# SERVICE BULLETIN

NO. 267

**Subject: McDonalds Universal Toaster (UTX-200) Bearing Retainer Upgrade Kit P/N 7000538**

**Figure 1**

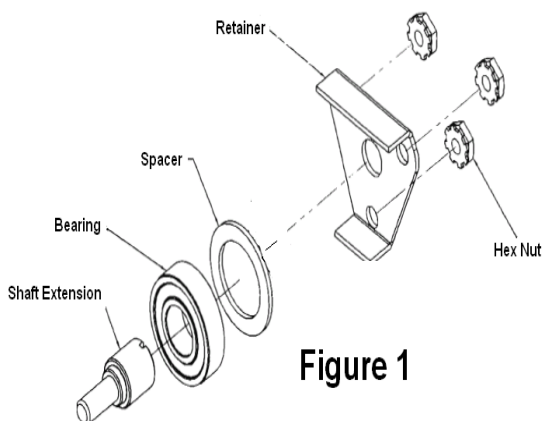
An area of concern involving the rear Vertical Conveyor Door Assembly has arisen. The Shaft Extension bolt (see Figure 1) that is located on the Power Cord (see Figure 2) side of the unit may possibly grind against the inner wall of the steel retainer as it rotates. Eventually, the extension bolt may cease and snap off within the main shaft. If this occurs, the Vertical Conveyor Door Assembly will not be sturdy when opened and will lean towards the side of the snapped extension bolt. We are taking a proactive approach in an attempt to prevent snapping of the extension bolt.

Please inspect the rear Vertical Conveyor Door. If it is unstable on the bottom left hand side call AJ Antunes immediately. If the door is stable, then remove the side panel that is towards the power cord side (see Figure 2) and remove the 3 hex nuts, retainer, spacer, and ball bearing. Install the new Bearing Retainer Kit. The kit will have a detailed instruction sheet.
